ADDENDUM #1

Title	Bid Number	Closing Date	Issued Date
Bid NO. 25-25 Steet Asphaltic Concrete Paving with Milling Services and Street Reconstruction Services	25-25	April 22, 2025, at 2:00 P.M. Central Standard Time	April 15, 2025

Huntsville Design Criteria	DRIVEWAYS		Scale: NONE
Revisions			FIGURE R-5

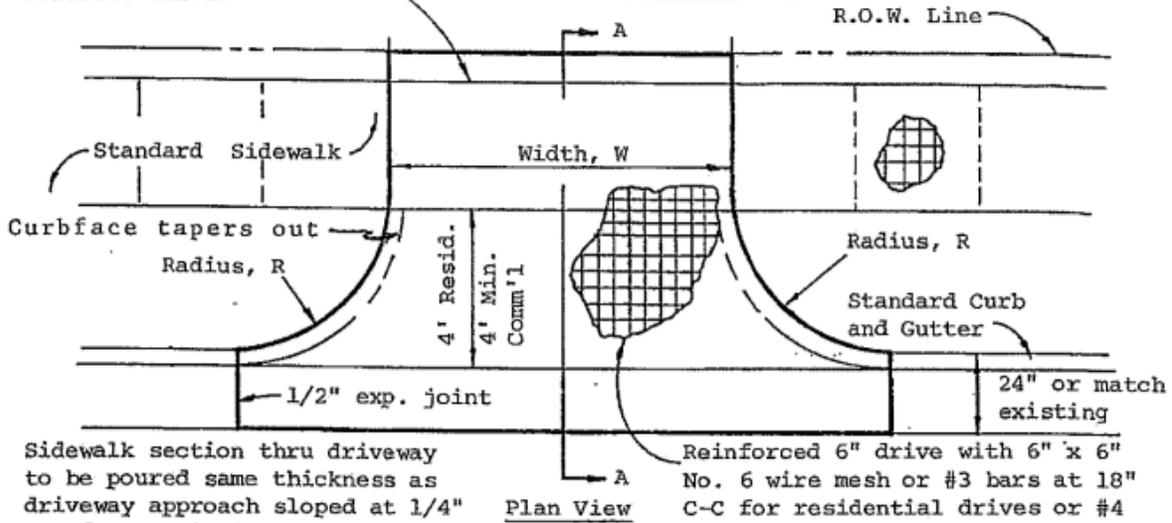
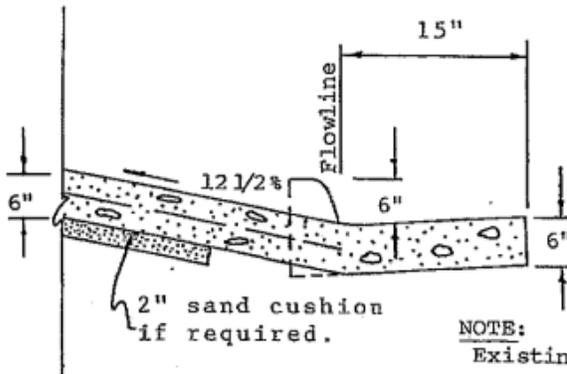
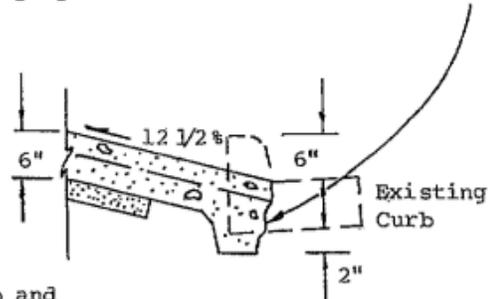
Question No. 3: Does the City have any specifications or standards for the Concrete pavement, Concrete driveways and Curb to be installed?

Answer: Standard drawings for concrete driveways and curb & gutter are attached/included.
